**PERRY NUCLEAR POWER PLANT**

Perry Nuclear Power Plant  
Docket No. 50-440  
Technical Specification Change  
Request: Remote Shutdown System  
Controls (T.S. 3/4.3.7.4)

## SUMMARY OF PROPOSED CHANGE

RCIC SYSTEM

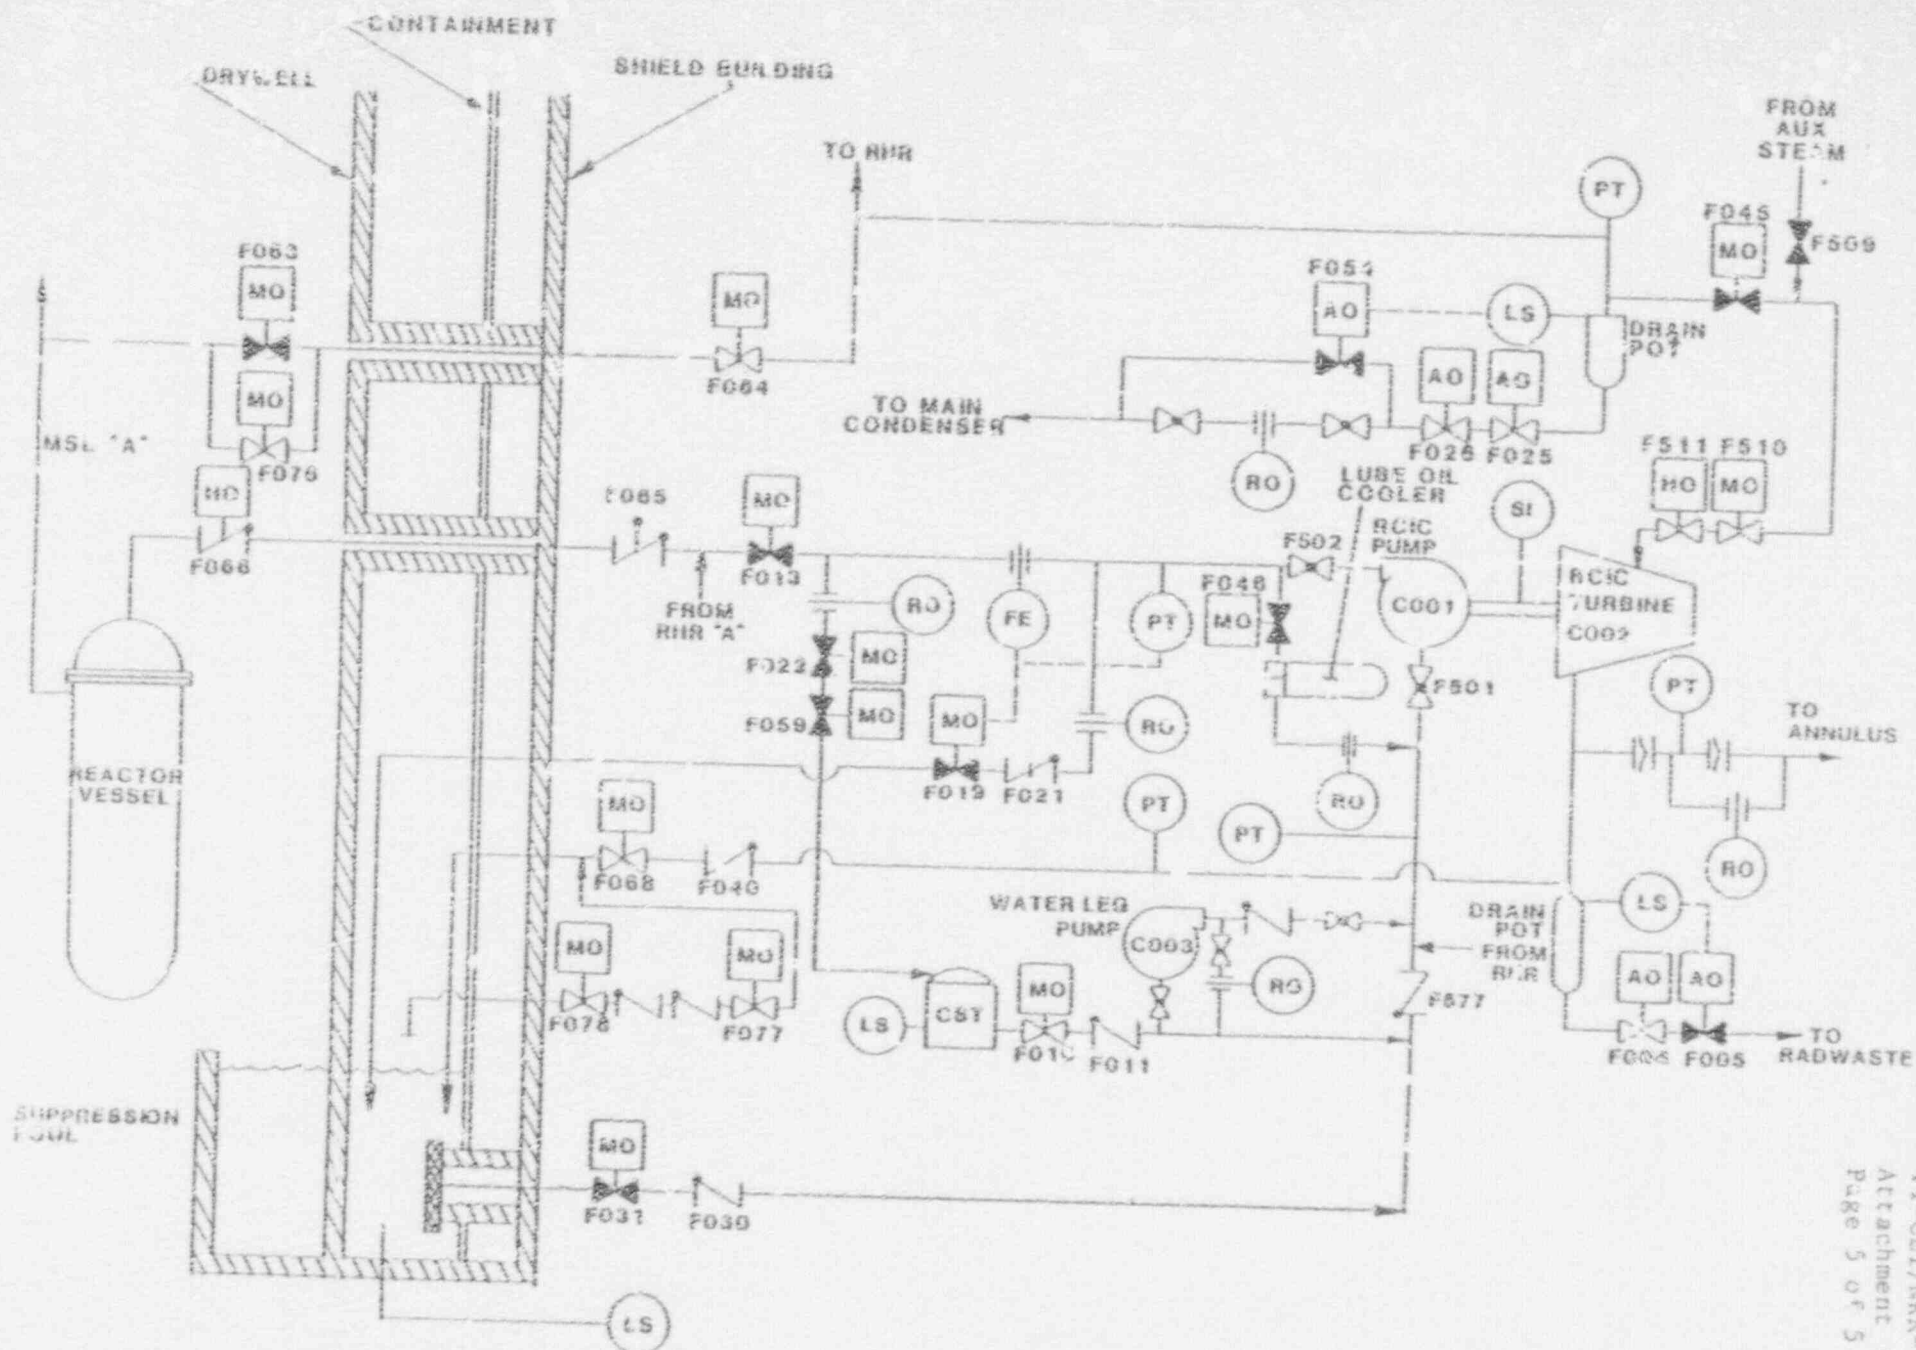
This change is requested in order to implement a design change which would convert RCIC valve 1E51-F046 from a Normally Closed (NC) Motor Operated Valve (MOV) to a Locked Open (LO) manually operated valve. The MOV will be disabled electrically from the Motor Control Center, Control Room and Remote Shutdown Panel. The valve will be locked in the normally open position and may be closed for maintenance purpose by the actuator handwheel only.

Per present design, valve 1E51-F046 has to open automatically from its normally closed position on a RCIC system initiation signal to supply cooling water to the RCIC lube oil cooler. This design is a carry-over from a previous BWR design where the cooling water from the RCIC pump discharge was routed through the lube oil cooler and then on to a barometric condenser. The cooling water was sprayed into the barometric condenser and was then routed to the Main Condenser through the barometric condenser drain. In the previous BWR design, this valve needed to be closed after RCIC system operation to prevent draining water from the Condensate Storage Tank to the Main Condenser. New BWR designs, such as those utilized at Perry, do not utilize a Barometric Condenser. The lube oil cooler outlet is returned to the RCIC pump suction line, making this a closed loop operation. In this design there is no concern of a water drainage problem to the Main Condenser and therefore, there is no need for this valve to close after RCIC system operation. Therefore, valve 1E51-F046 can be a manually operated open valve. This design change was approved by General Electric, PNPP's Nuclear Steam Supply System (NSSS) supplier.

With the new design, the valve will be locked in the normally open position and cooling water to the RCIC lube oil cooler will always be available whenever RCIC pump 1E51-C0001 runs. By converting the valve from a NC MOV to a LO Manual Valve there will be no question of whether or not the valve has opened to allow cooling water to the lube oil cooler. There is no need for the valve to close when the RCIC system is not running because this is a closed loop design. By leaving the valve in the normally open position the operability of the RCIC system is enhanced as it removes one active component from the system and replaces it with a passive valve. RCIC system operation from the Control Room and from the Remote Shutdown Panel as required by General Design Criteria 19 (USAR section 3.1.2.2.10) will not be affected because this will be a LO Manual Valve which requires no remote operation.

This amendment request proposes to remove reference to the controls for the RCIC system pump discharge to lube oil cooler valve 1E51-F046 from PNPP Unit 1 Technical Specification 3.3.7.4, Table 3.3.7.4-1. A copy of the marked up technical specification page reflecting the requested change is provided in Attachment 2.
